Research Report 1434

**Human Factors Assessment:  
Light Armored Vehicle,  
Maintenance/Recovery Vehicle (LAVM/RV)**

**Gregory S. Krohn**  
Essex Corporation

**December 1986**

Figure 14. Crew members loading the APU onto its storage rack.

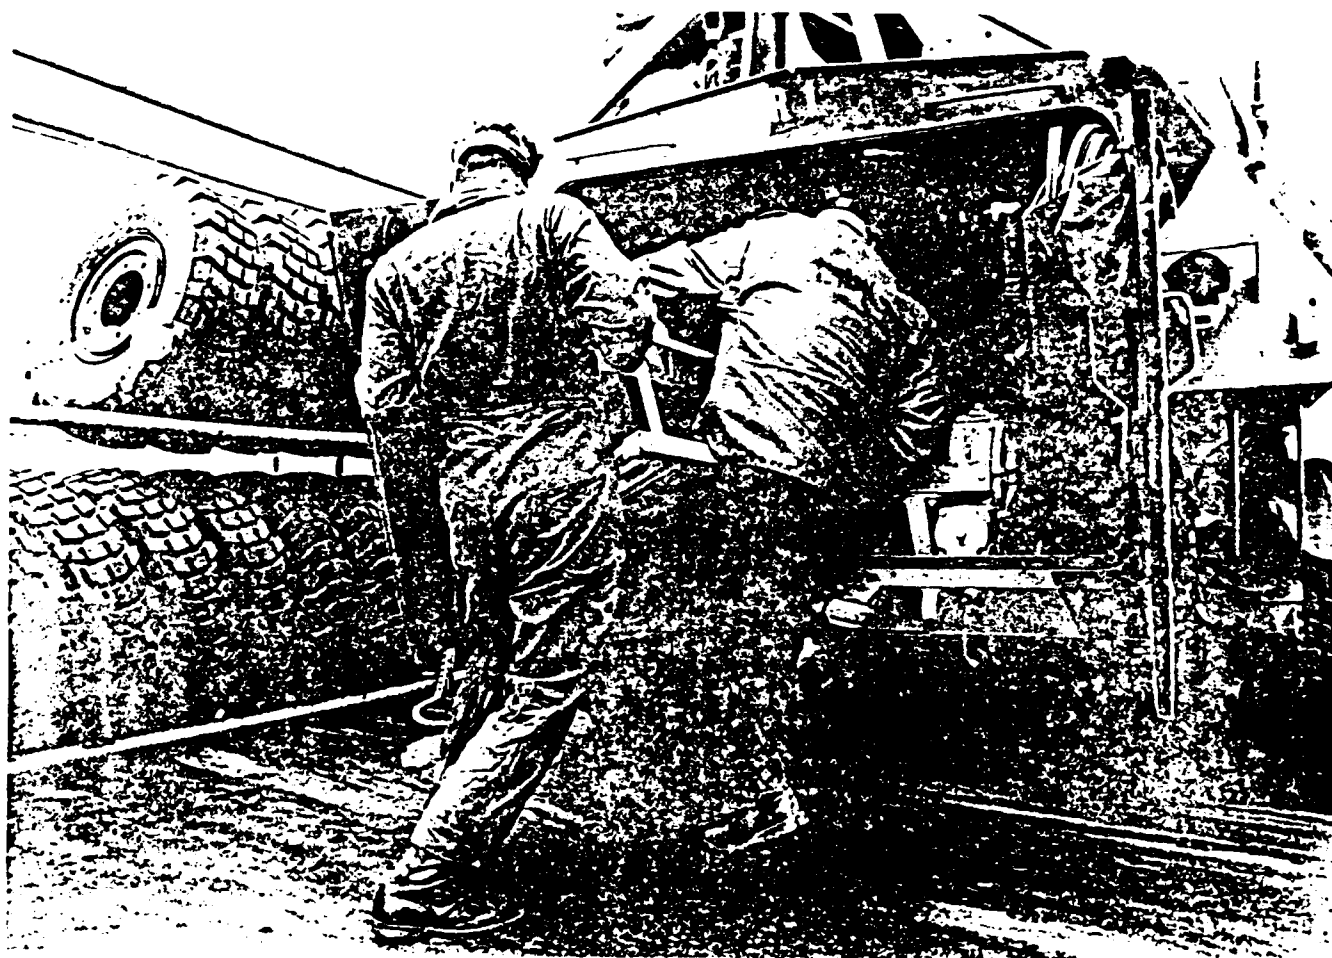
**APU storage location.** The crews rated the portability of the APU/welder/generator as inadequate (mean rating, 2.5). Moreover, 60 percent of the crews reported that handling the APU was hazardous. Figure 14 shows the crew attempting to load the APU onto the vehicle's storage rack; a procedure which took 15 minutes during each of three separate loading trials. The human factors deficiency results from a combination of the APU's weight (375 lb (170 kg)) and its storage location (APU handrail height to ground is 45 in (114 cm)). Moreover, loading the APU is difficult because its storage rack is alongside the rear wall of the vehicle and access to the rack from the left side is completely blocked by the left rear door. During the loading of the APU, only two to three crew members can position themselves to lift and align the APU to its storage rack (lifting weight per person is 187.5 to 125 lb (85.05 to 56.70 kg)). MIL-STD-1472C limits the weight to 50 lb (3 kg) for a height of 48 in (127 cm). This human factors deficiency is likely to result in:

1. Injury to the crew,
2. Equipment damage to the APU or storage rack,
3. Abandonment of the APU during an emergency.

Design changes might include repositioning the APU to allow more of the crew to participate in lifting the device. However, even if all five crew members lift the APU, the lifted weight per person is 75 lb (34 kg) and violates the MIL standard. A better solution might be to add a sliding carriage rack to the APU storage rack that slides out and locks in place beyond the rear door opening. It would then be possible to load the

APU onto the carriage rack using the crane and some type of attachment device. Should this solution be implemented, the APU attachment device should be permanently attached to the APU to avoid its loss.

Figure 18. The hydraulic hoses of the winch drive motor are unprotected and are tripping hazards.

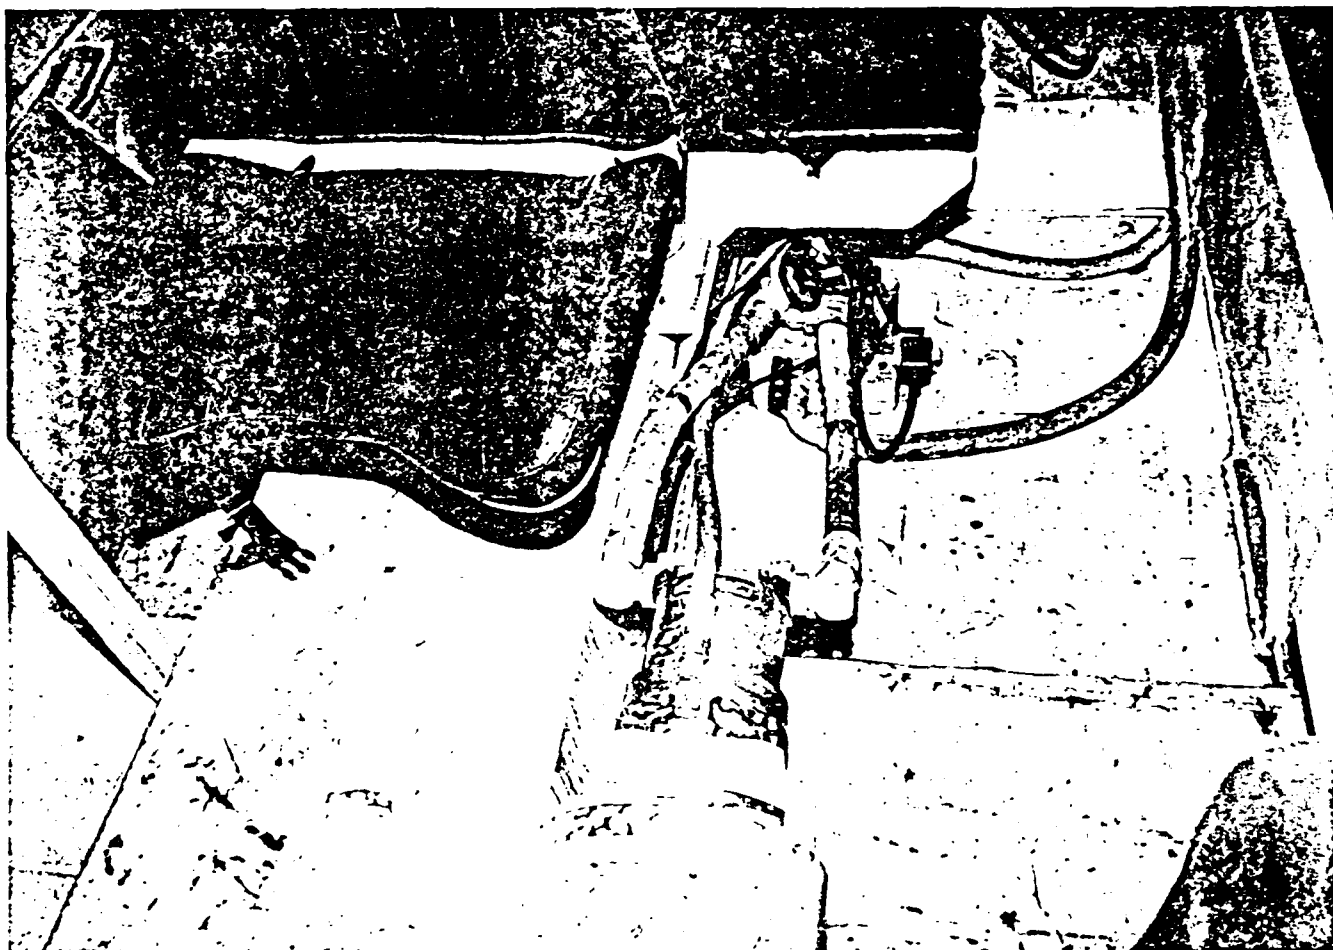
**Hydraulic hoses.** Two crew members reported that their feet had become entangled in hydraulic hoses. Figure 18 shows the winch drive motor and hydraulic hose assembly next to the rigger's seat. Hoses that are unprotected in passageways are a tripping hazard. Moreover, the service life of the hoses and fittings are reduced when they are continually bumped and abraded. The winch drive motor hydraulic hoses should be protected.

Figure 19. The amphibious propeller extends beyond the sponson and wheel.

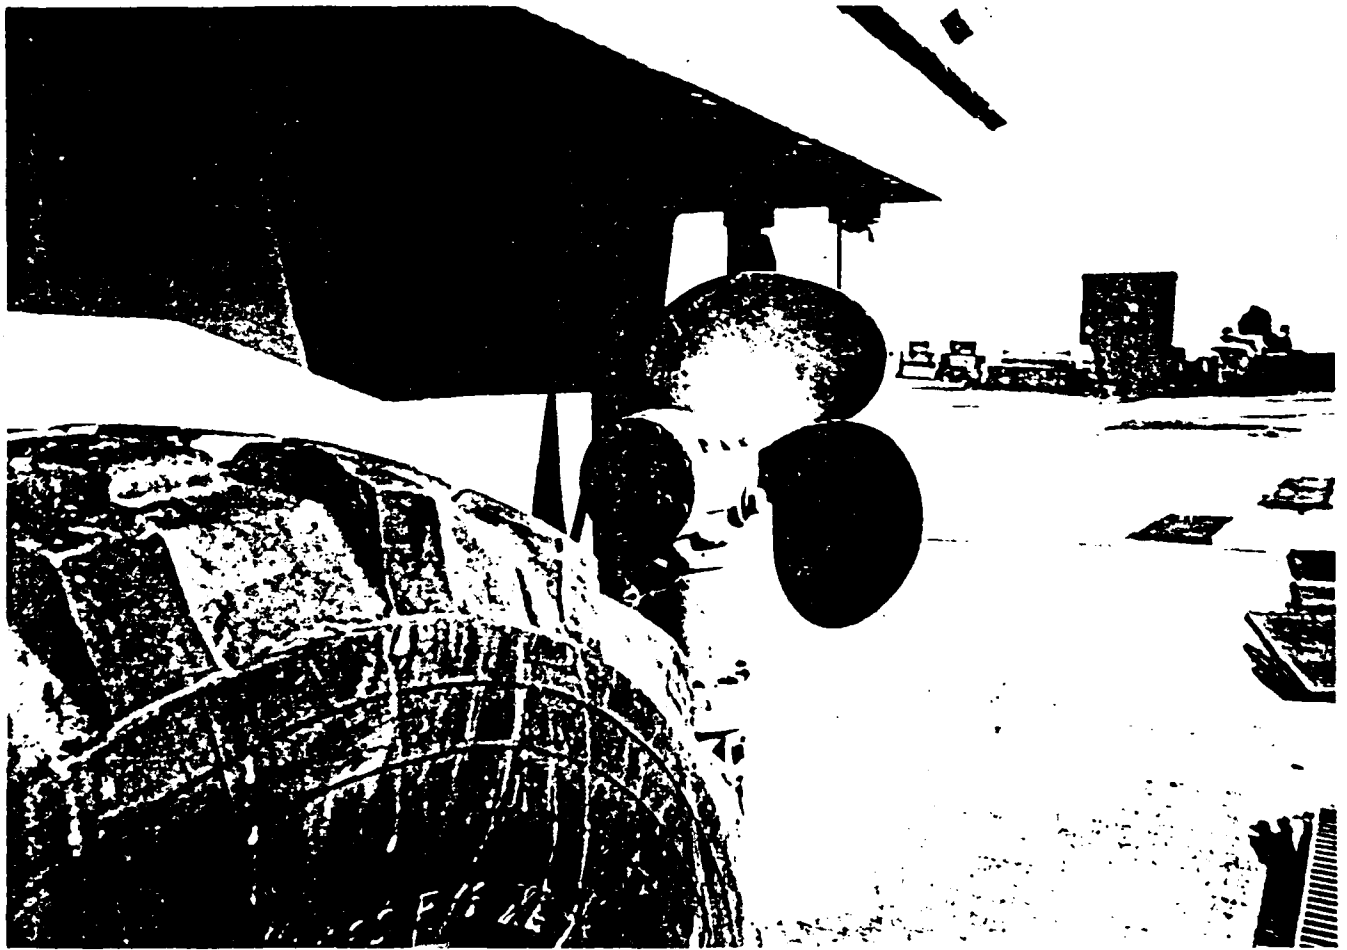
**Amphibious propellers.** Figure 19 shows one of the propellers at the rear of the vehicle that are used for amphibious operation. The propellers are unguarded and extend 1 in (2.5 cm) beyond the edge of the sponson and 2 in (5 cm) beyond the outer edge of the rear wheel. The propellers are likely to be out of the sight of personnel walking around the corner of the vehicle from the rear. Moreover, the large open space surrounding the propellers increases the chance that objects might collide with the blades when they are spinning. It is in close quarters, such as on naval ships, that the propellers might be engaged while personnel are in the area. The propeller blades should be guarded.
